RE: La Luz del Oeste, Unit 4, Tracts M & N

RE: La Luz Del Oeste Unit 4
Grading and Drainage Plan

Re: La Luz del Oeste, Unit 4 Grading and Drainage Plan Engineer's Stamp dated 08-28-2013 (F-11/D002A)

Re: RESPONSE TO COMMENTS CONCERNING THE LA LUZ DEL OESTE, UNIT 4 GRADING AND DRAINAGE PLAN DATED JULY 30, 2013 (F-11-D002A)

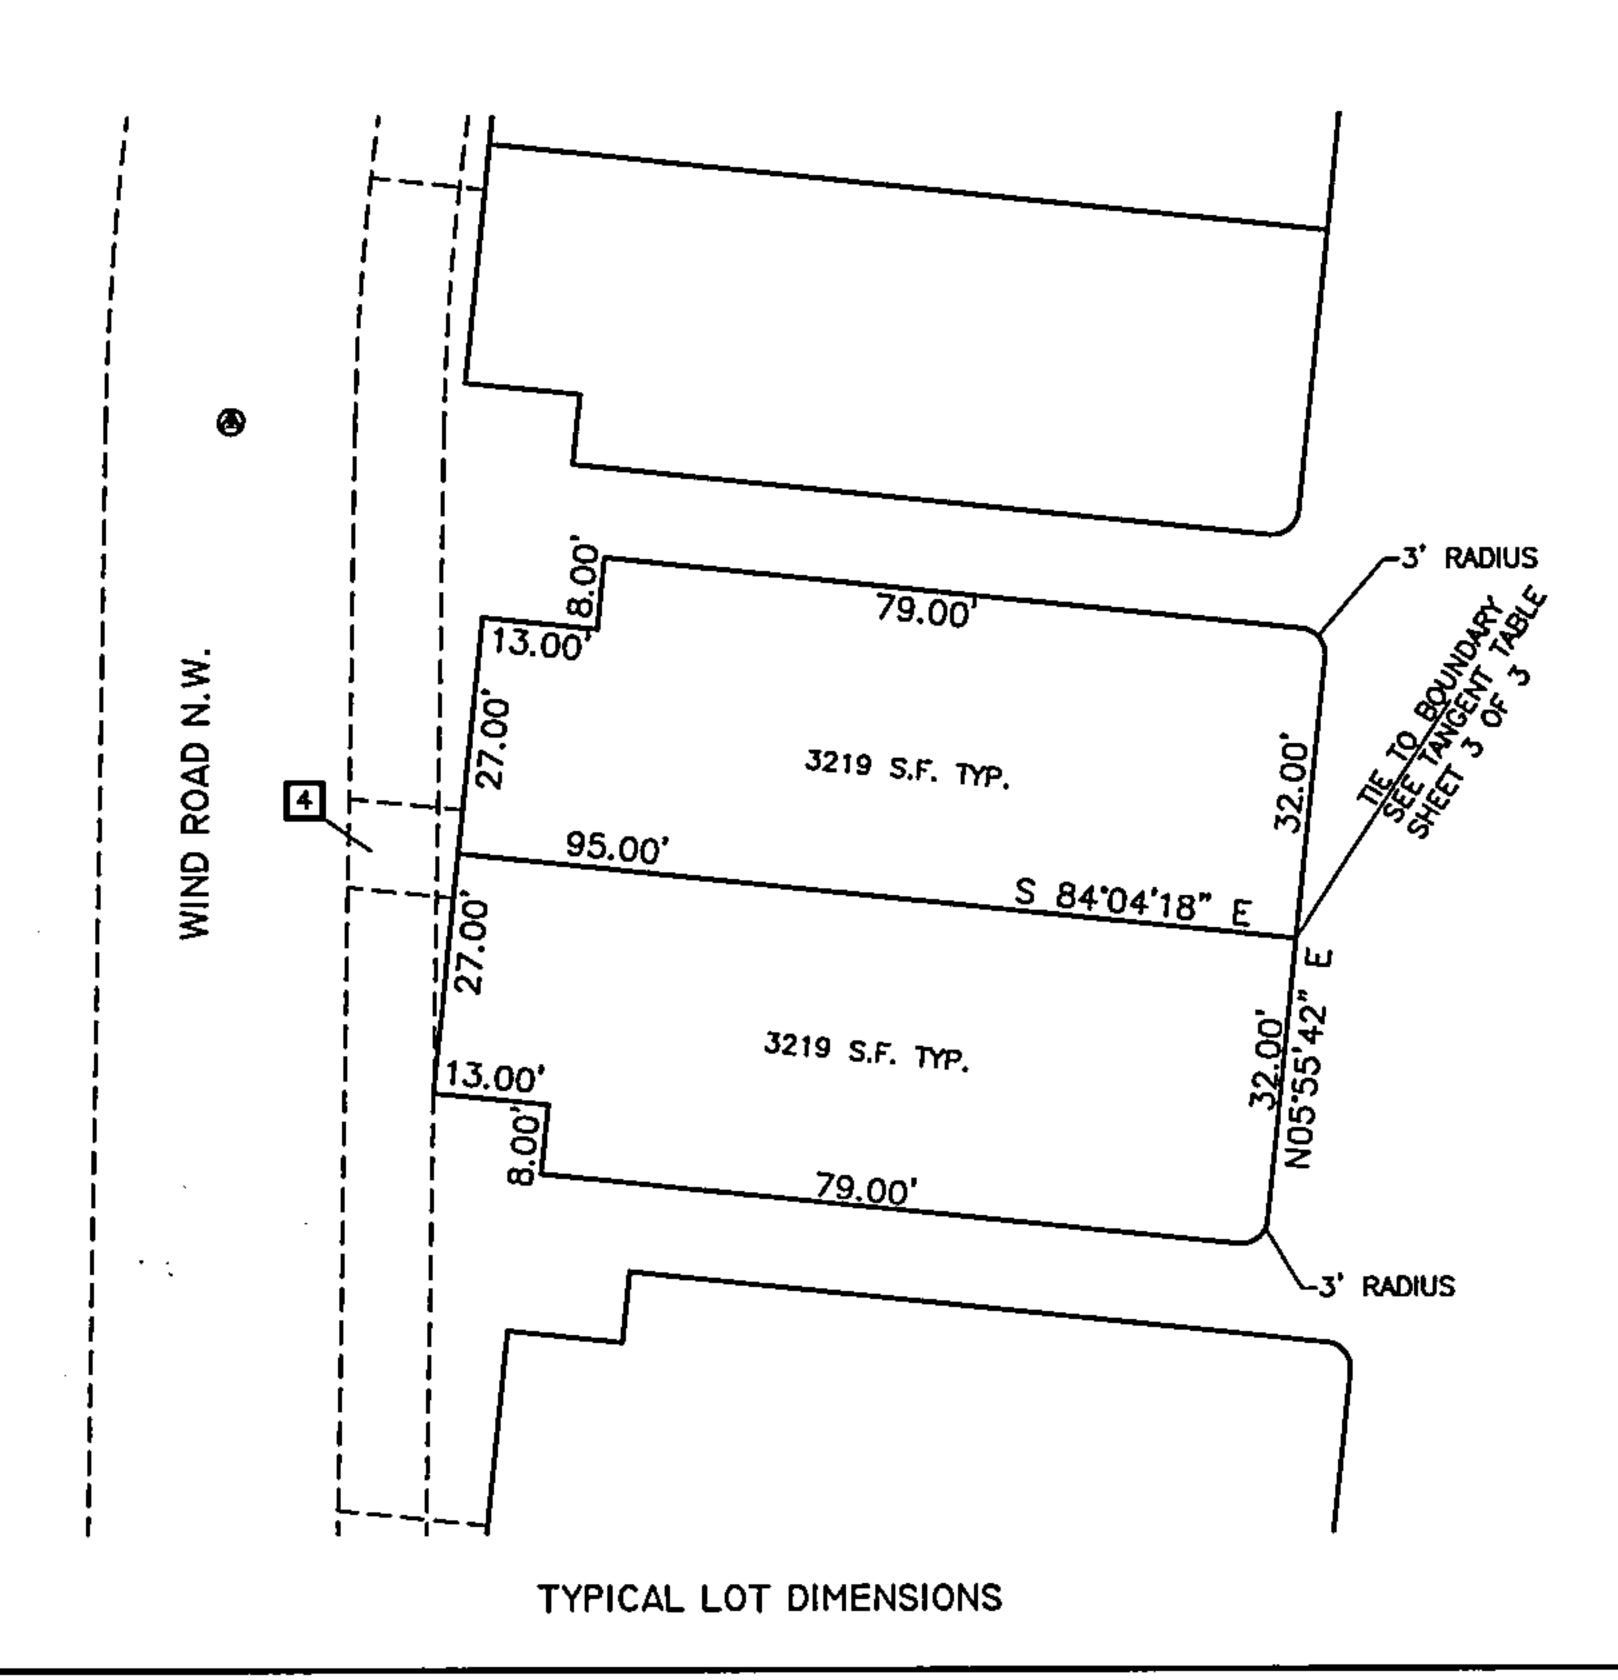
Basin 105 drains to a low area between roads. We have included a small earthen berm to help retain the runoff within Basin 105. Basin 110 or the Mill Road Basin has been eliminated and the runoff from Mill Road now drains to the basins on both sides of the road (Basin 108 and the new Basin 110). A copy of the original grading plan has been included for reference.

Runoff from the eastern edge of Basins 111 and 113 drain to the ponds in each basin since the road is sloped to the west and a small portion of each existing home drains to the west. A copy of the original grading plan has been included for reference.
